## MEMORANDUM

To: Pine Plains Planning Board  
From: R. Chamberlin, PE/PTOE  
Subject: Preliminary Completeness Review, Carvel Proposal, Pine Plains, NY  
Date: 7 April 2008

Pine Plains United has retained Resource Systems Group to review the completeness and substance of Chapter 11 (Transportation and Traffic) of the Carvel Property Development DEIS.

**Figure 1: Proposed New Street Intersections on NYS 199 West of Stissing Mountain Road**

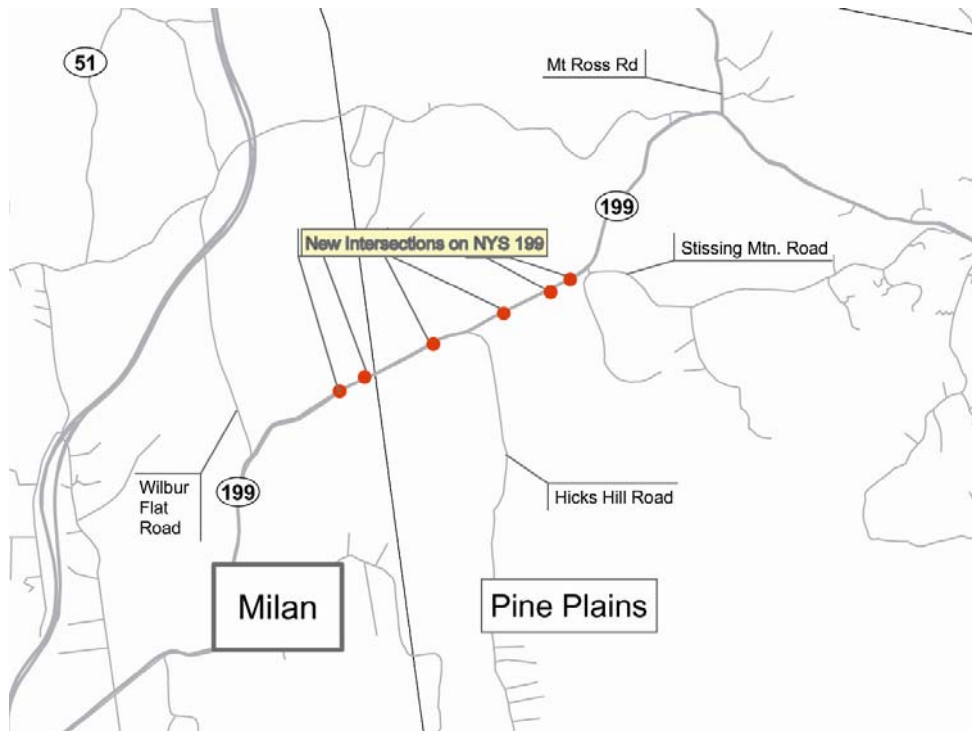
approximately 2.8 miles of frontage on Route 199. Currently there are 7 local roads that intersect Route 199 within this 2.8 mile segment. The proposed site plan shows a total of 16 local road intersections resulting from the project. Between the western project boundary and Stissing Mountain Road, a total of 6 new intersections are proposed (Figure 1).

Numerous new curb cuts on a rural arterial create safety concerns and are counter to sound access management principles. Each new intersection with NYS Route 199 will need to be analyzed for left turn lane warrants. The Planning Board should review, at minimum, conceptual designs for any left turn lanes on Route 199 as they will have a significant environmental and aesthetic impact. This type of information is critical and should not be left for the Planning Board's consideration after final approvals have been granted.
